Groundwater Transfer Review Summary Form

Transfer/PA # T- 14904

Application: T-14904

Applicant Name: Treasure Valley Community College

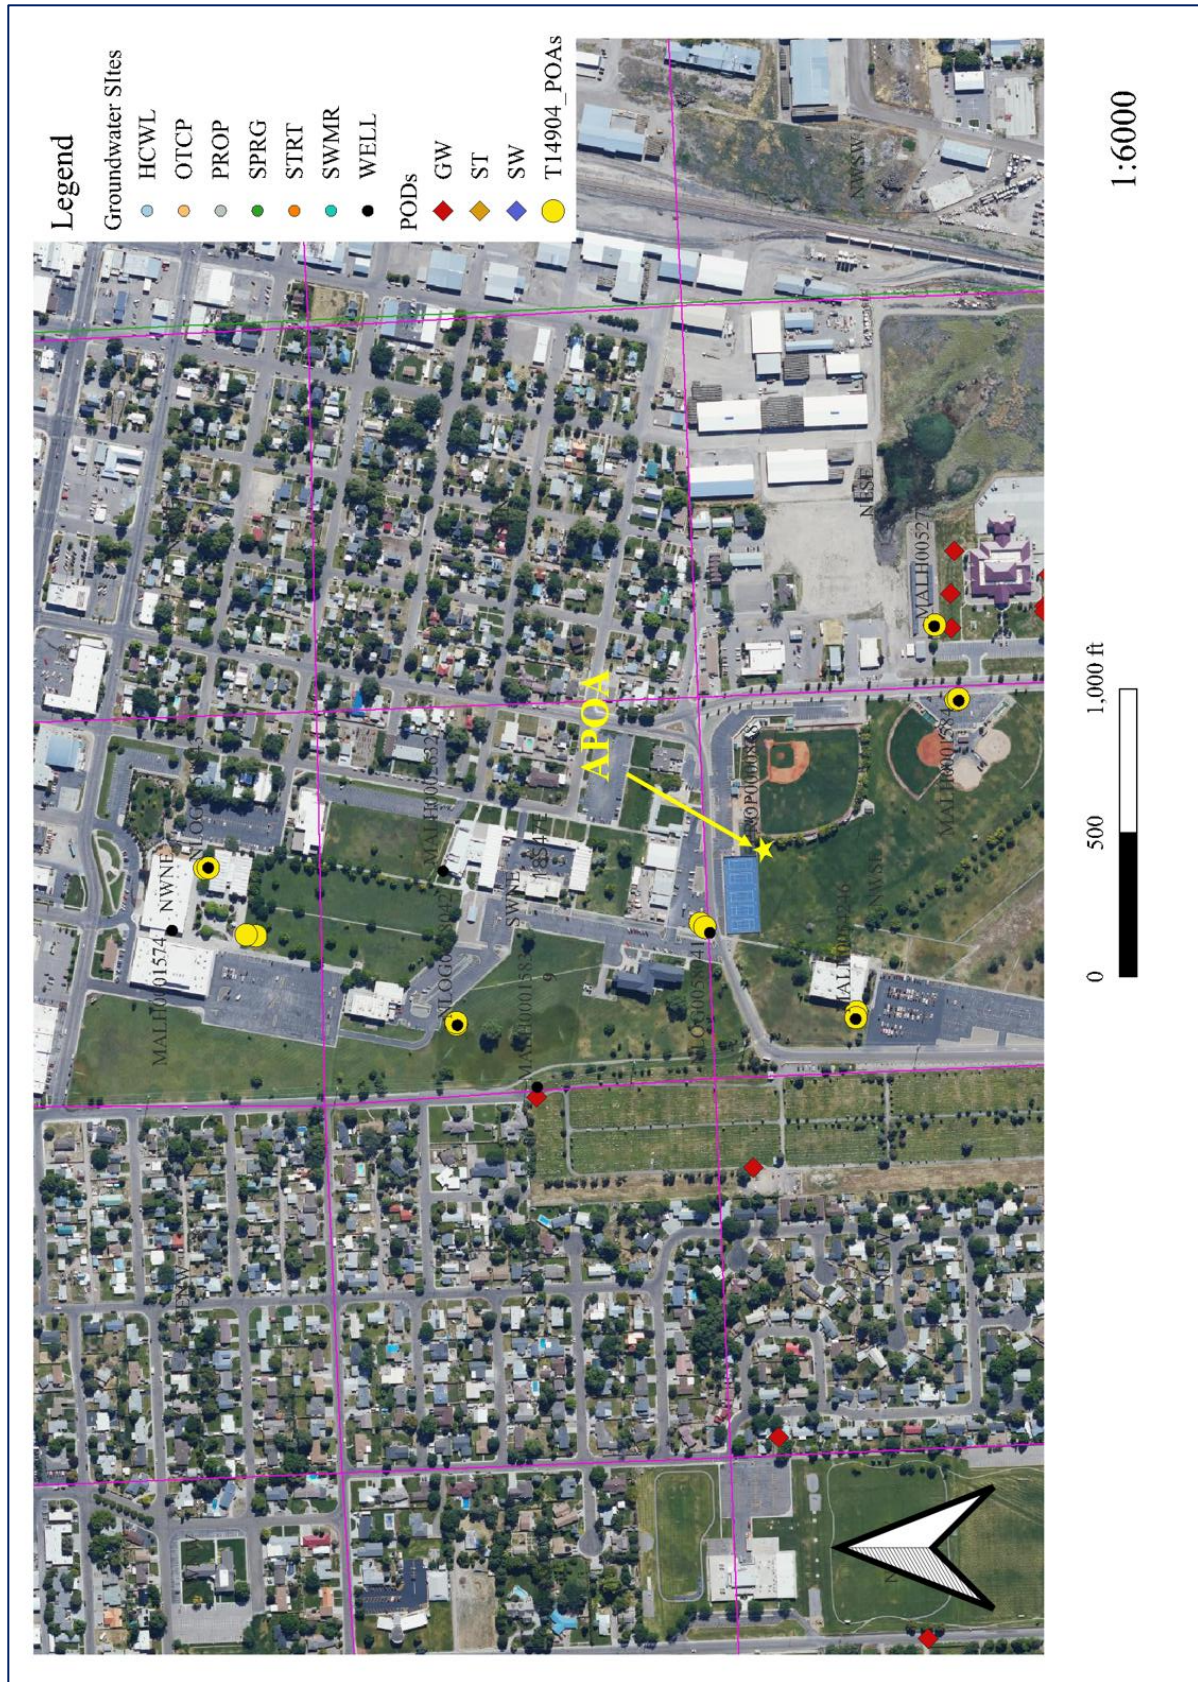
9. Any additional comments: The proposed APOA well is located within a group of wells authorized under the two water rights to be amended. Therefore, assuming the pumping rate and volume remain unchanged, no additional interference with local surface water or groundwater sources is anticipated.

The proposed APOA "Well 9" lies within the perimeter of previously authorized POA wells under Certificates 89437 and 99006.
